Markup of Existing Technical Specifications Bases

T.S. Bases 3.3 & 3.5

Figure 3.5.2-16a

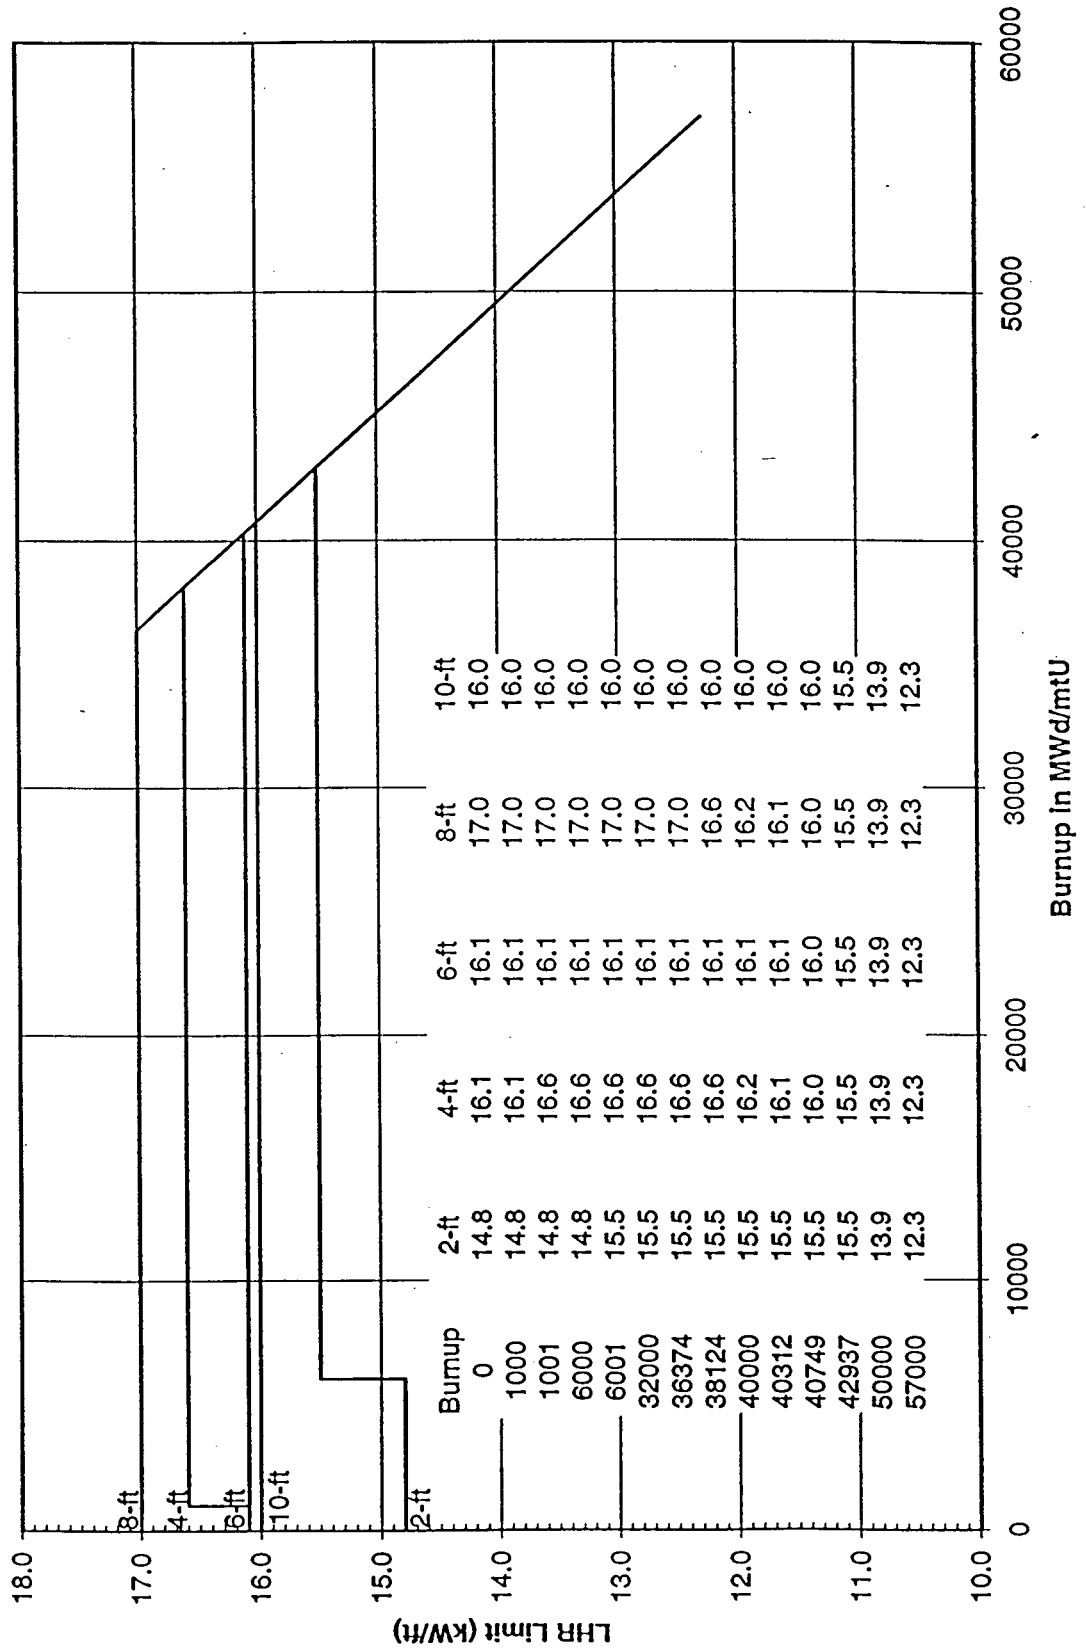
LOCA LHR Limits for Mk-B8 Fuel (applicable only for O3C17)

Figure 3.5.2-16d

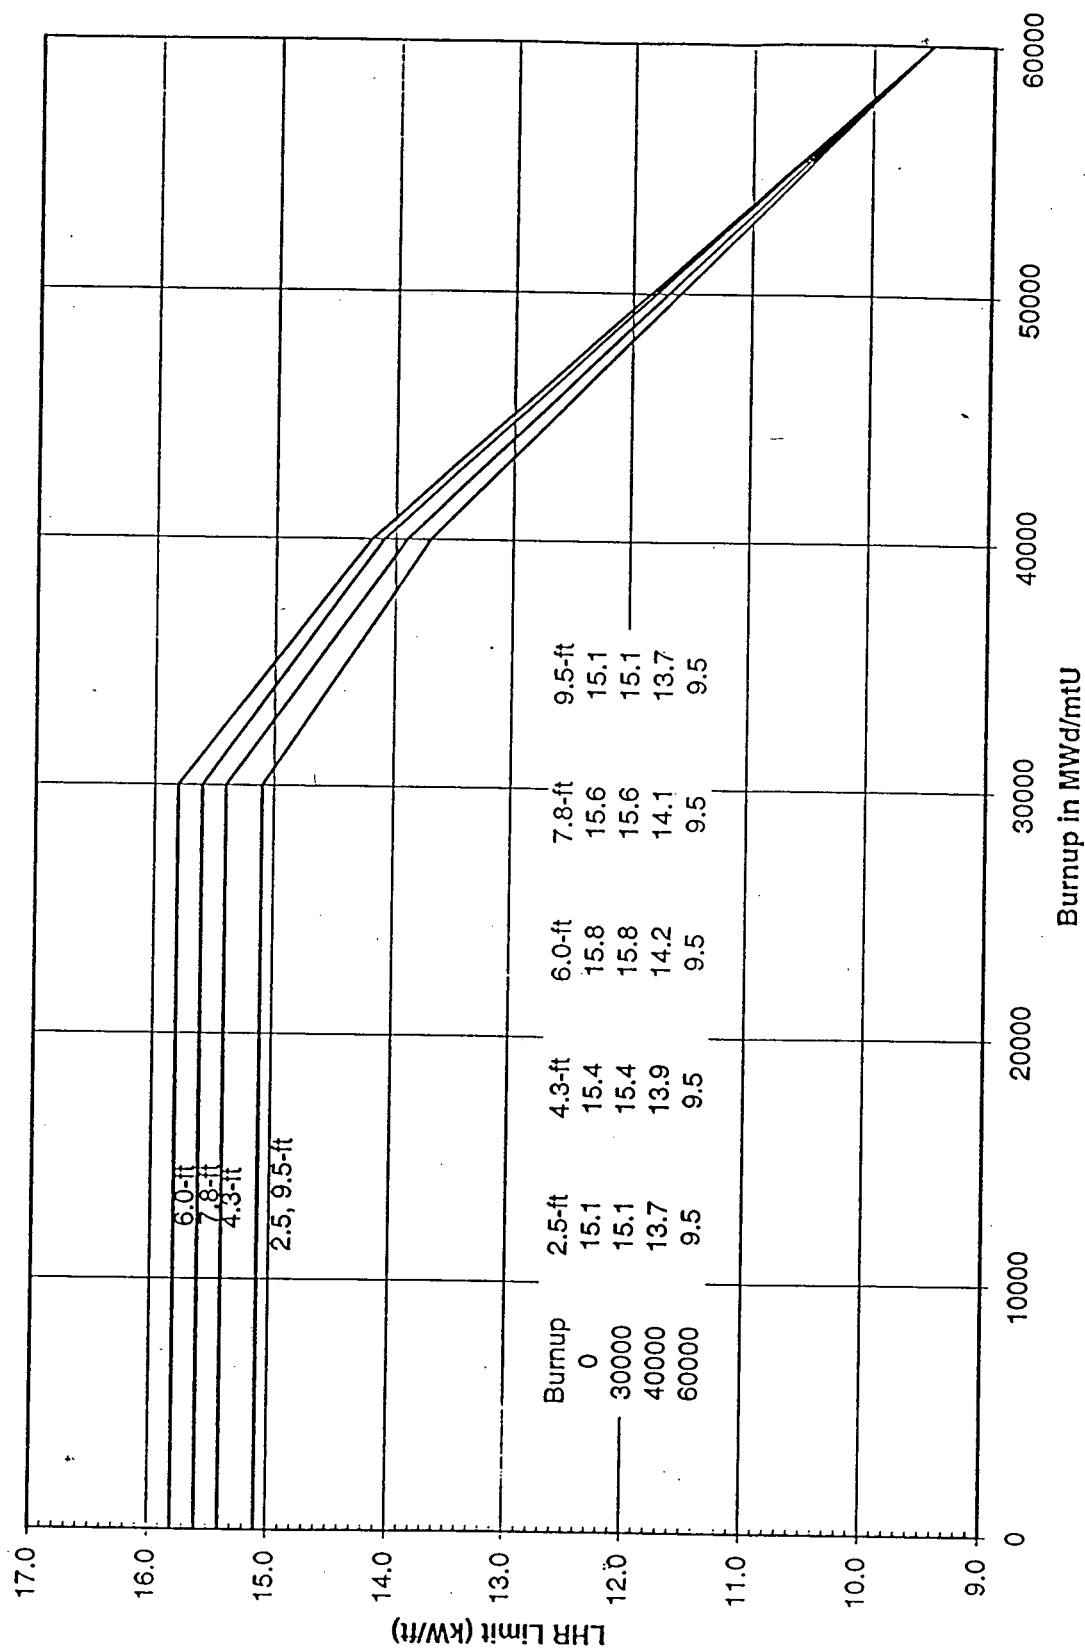
The power-imbalance envelope obtained in accordance with the approved methodology is based on LOCA analyses ^{and d} which have defined the maximum linear heat rate (see Figures 3.5.2-16a, b, and c) such that the maximum clad temperature will not exceed the Final Acceptance Criteria. Corrective measures will be taken immediately should the indicated quadrant tilt, rod position, or imbalance be outside their specified boundary. Operation in a situation that would cause the Final Acceptance Criteria to be approached should a LOCA occur is highly improbable because all of the power distribution parameters (quadrant tilt, rod position, and imbalance) must be at their limits while simultaneously all other engineering and uncertainty factors are also at their limits.** Conservatism is introduced by application of:

The power-imbalance envelope obtained in accordance with the approved methodology is based on LOCA analyses which have defined the maximum linear heat rate (see Figure 3.5.2-16a, b, c, and d) such that the maximum clad temperature will not exceed the Final Acceptance Criteria. Corrective measures will be taken immediately should the indicated quadrant tilt, rod position, or imbalance be outside their specified boundary. Operation in a situation that would cause the Final Acceptance Criteria to be approached should a LOCA occur is highly improbable because all of the power distribution parameters (quadrant tilt, rod position, and imbalance) must be at their limits while simultaneously all other engineering and uncertainty factors are also at their limits.** Conservatism is introduced by application of:

Oconee Nuclear Station
Figure 3.5.2-16a

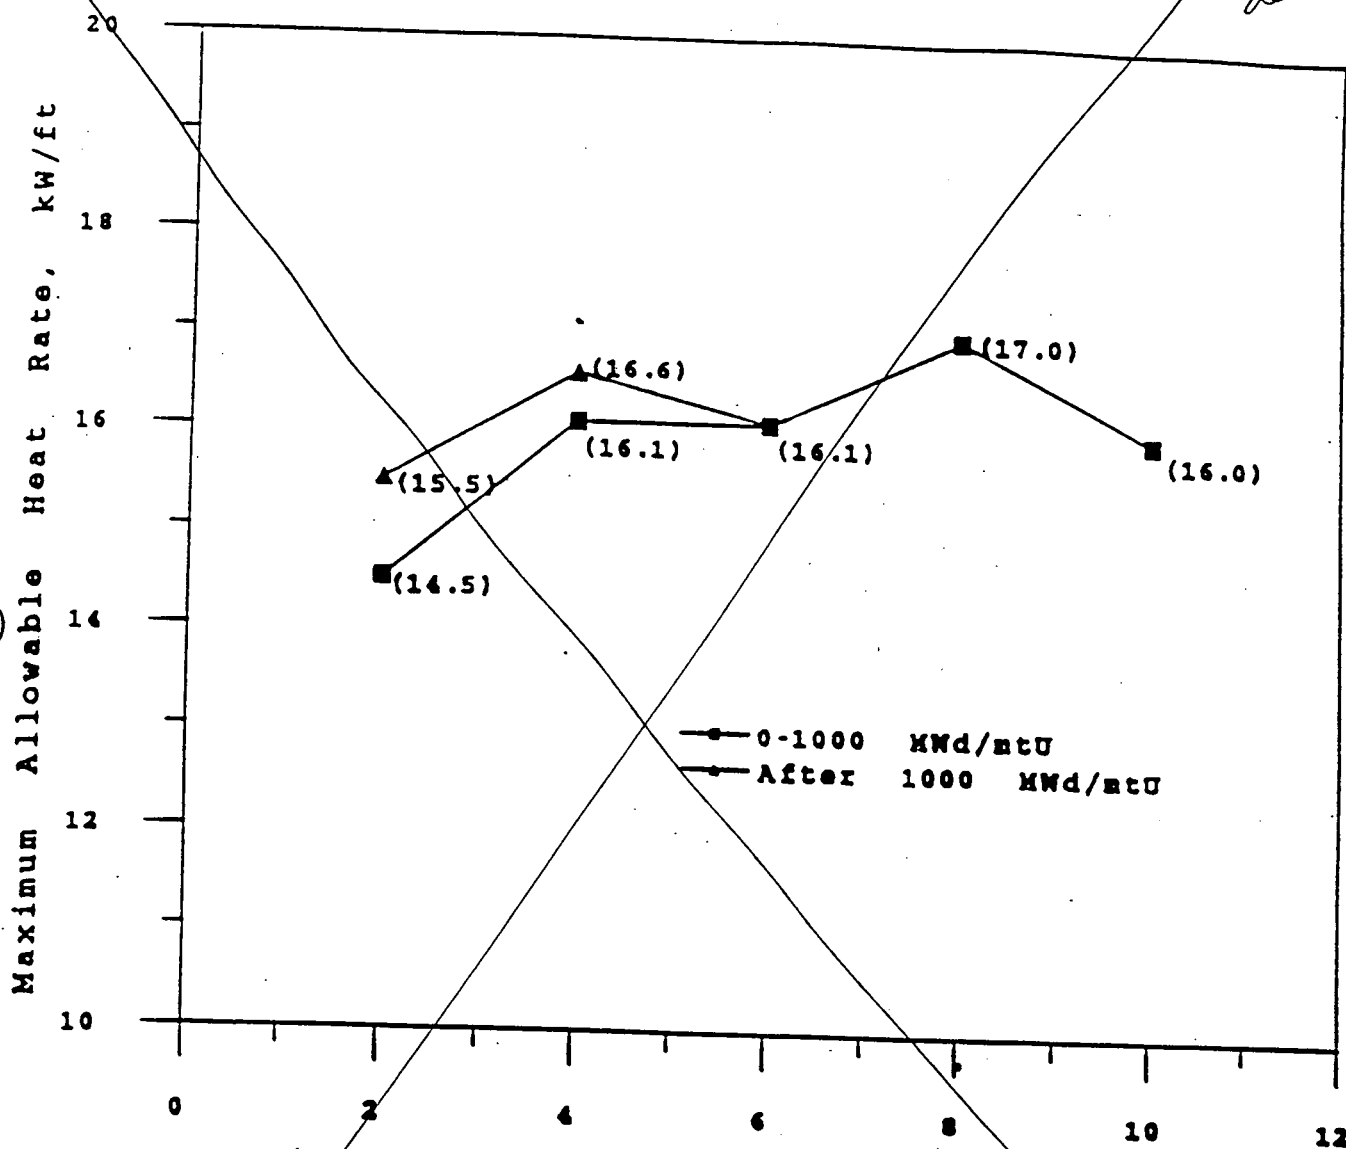
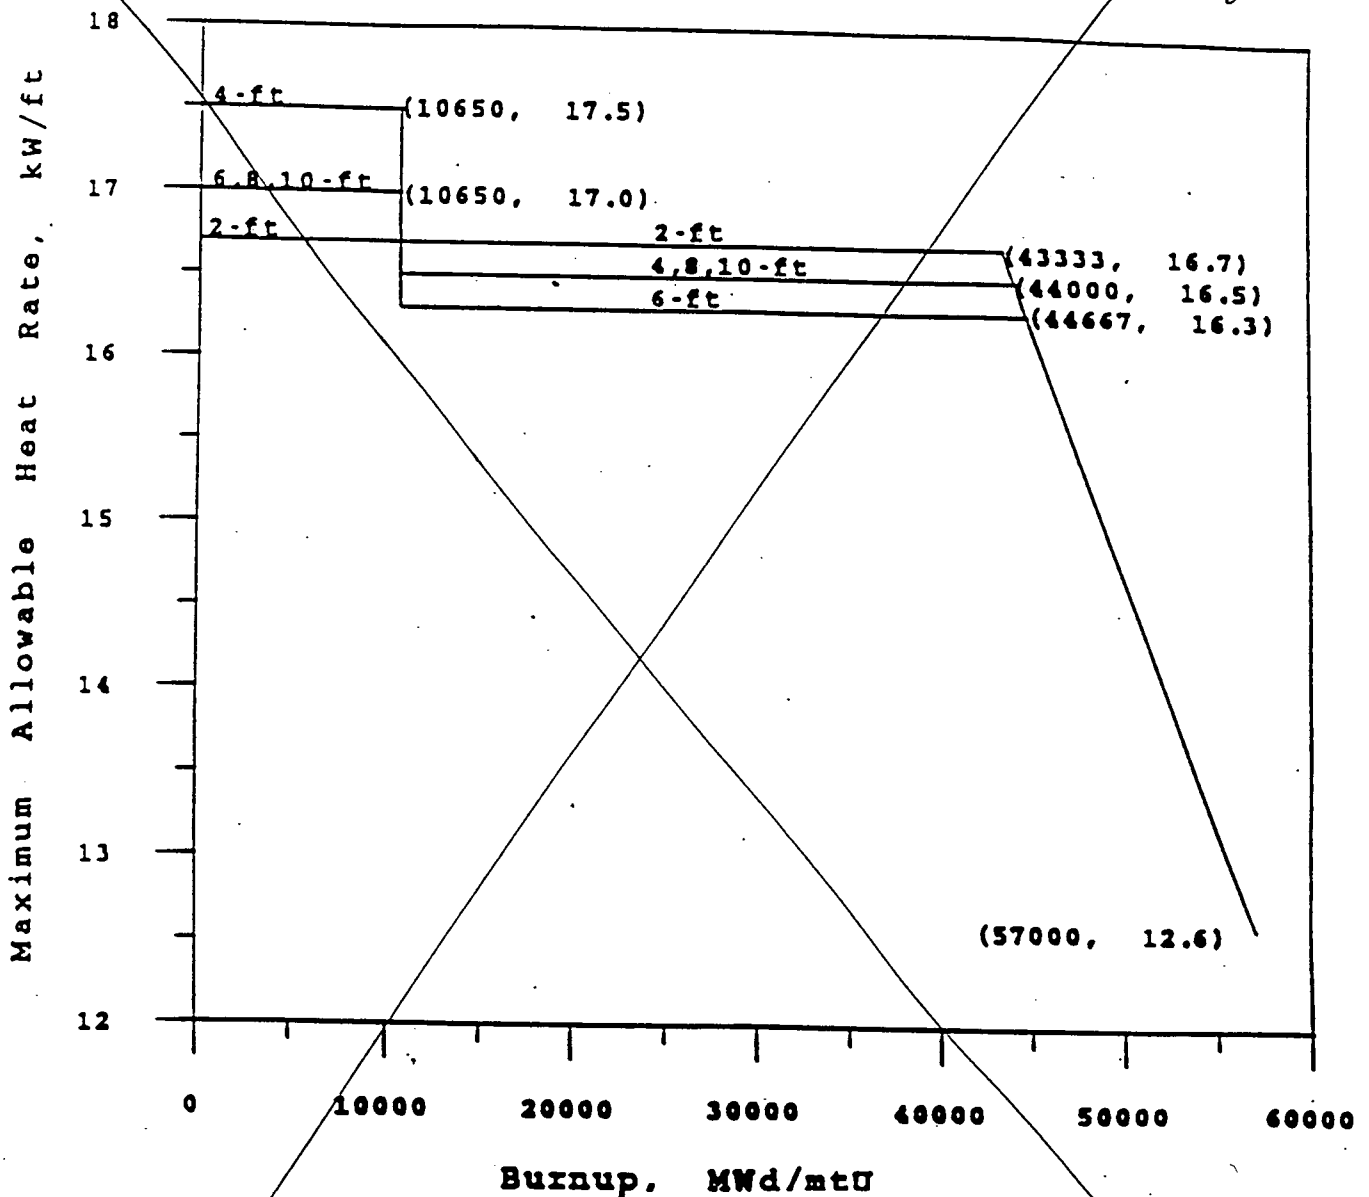
delete

Oconee Nuclear Station
Figure 3.5.2-16b

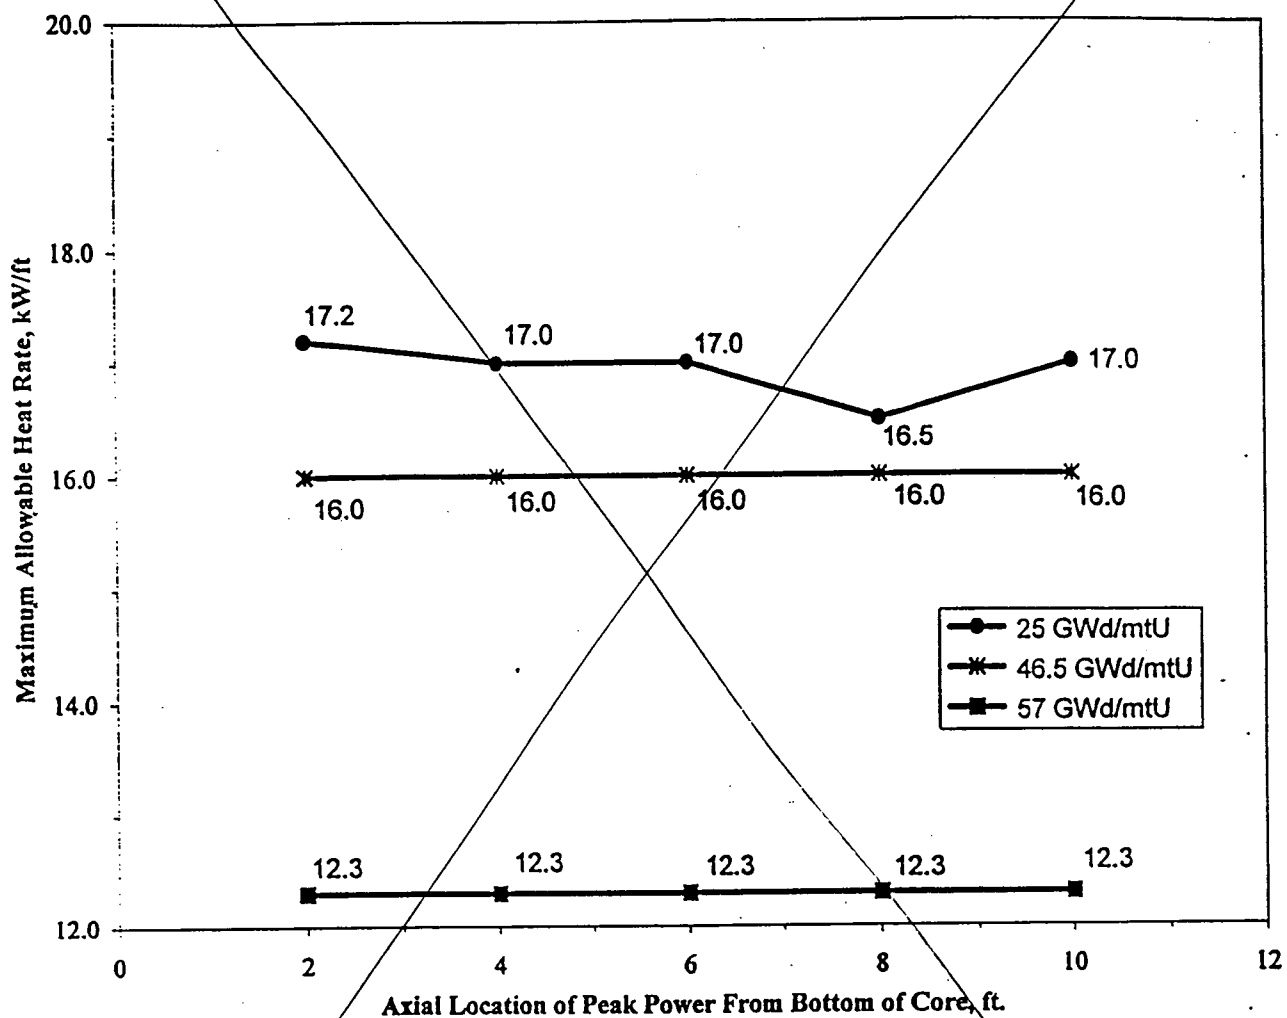
delete
